**Historical Architectural Review Board
COA Preliminary Review Sheet**

HDC-2024-00094

Address: 728 Liberty Street

Proposal: Solar Panel Installation

Roof Plan (Applicant)

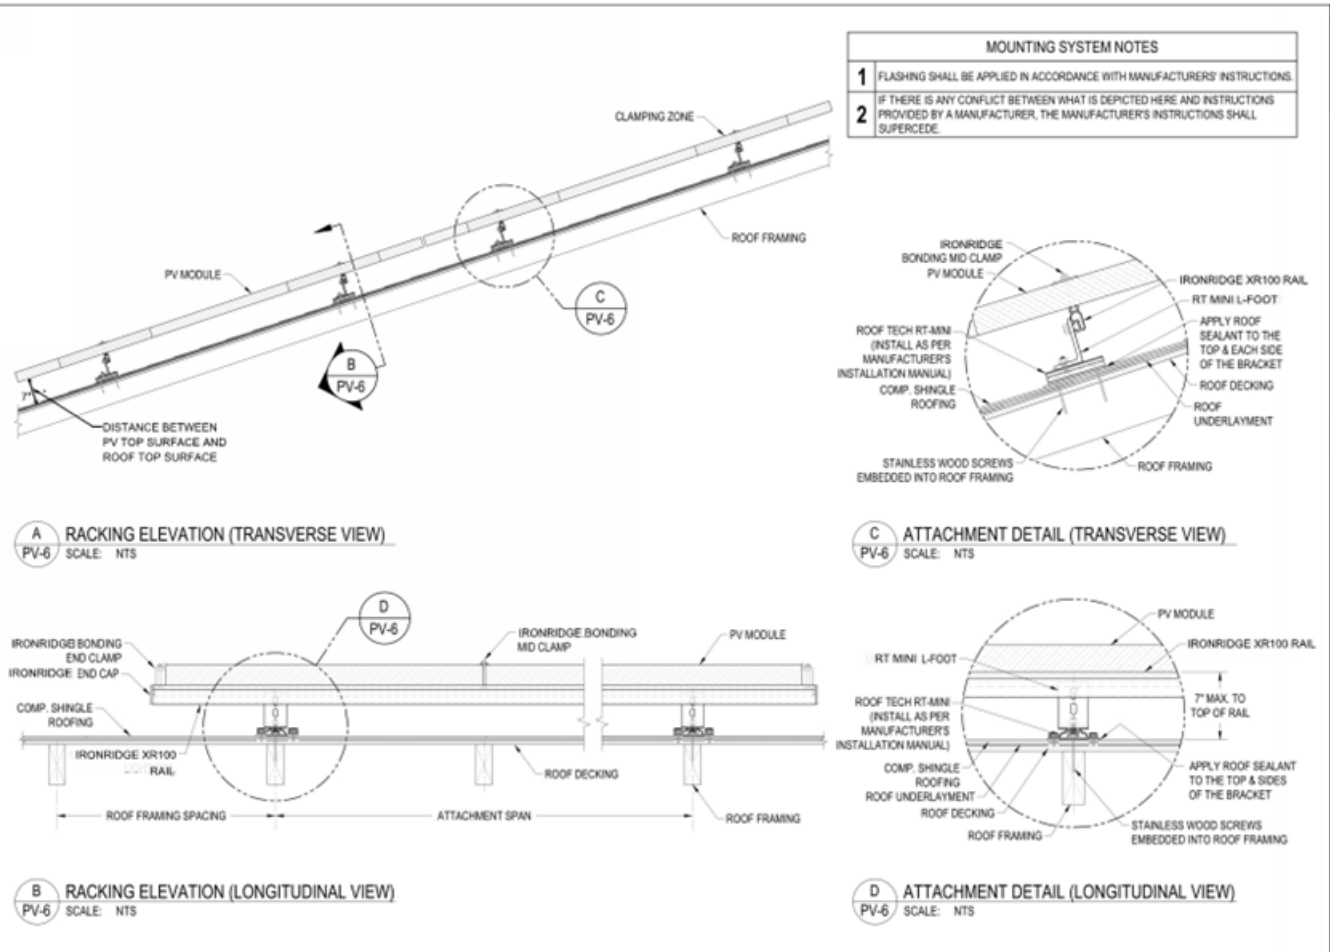
While solar panel installation is typically a staff-level review, staff recommended this application is reviewed by the HARB, given the extent of roof coverage. The application indicates that the 24 solar panels would be installed over the front and rear roof slopes, with nearly full roof surface coverage. Guidelines Section 3.10.3 states to minimize visibility of solar panels, locating collectors on rear roof slopes whenever possible, and/or as far back from the street as possible, and to avoid locating panels on roofs facing the street or the main façade. In reviewing view angles from the public right-of-way, the existing roof surface is not visible. This visibility may change when the panels are installed. The proposed installation calls for mounting the panels parallel to the roof surface, which is appropriate per the Guidelines, and that there is a maximum 7" from the existing roof surface to the top rail of the panel installation.

- In the submitted drawings, the "top rail" does not appear to align with the top of the solar panel itself. What is the expected total height of the system from the surface of the existing roof?
- Was there consideration for installing panels on the rear slope of the roof only?

Discussion: The applicant noted they submitted revised plans for the project that address some of the staff recommendations related to the visibility of the panels from the front of the structure. They reduced the number of panels from 24 to 15. The applicant noted 6" is the distance between the roof and panels (7" is the maximum distance permitted.) They are also proposing to move the electrical equipment indoors to the basement, instead of at the northeast corner of the property on the exterior. The applicant would like to know if solar panels are acceptable on the front slope of the building; the applicant thinks visibility will be minimal, due to the footprint of the building. The power disconnect will be located on the exterior of the building per NEC rules and the conduit will run up the side of the house. Mr. Huber noted that the preference would be to run this on the back of the house, which is not visible from the right-of-way. The applicant noted that they will also replace the roof to provide a solid foundation for the panels. Mr. Jordan asked what the existing roof material is; it was noted that slate is the current material that will be replaced with shingles. It was noted that roof replacement was not part of the application, so a separate application for the roof replacement will be needed.

- Alternate configuration utilizing only the rear surface of the roof, as presented, be installed.
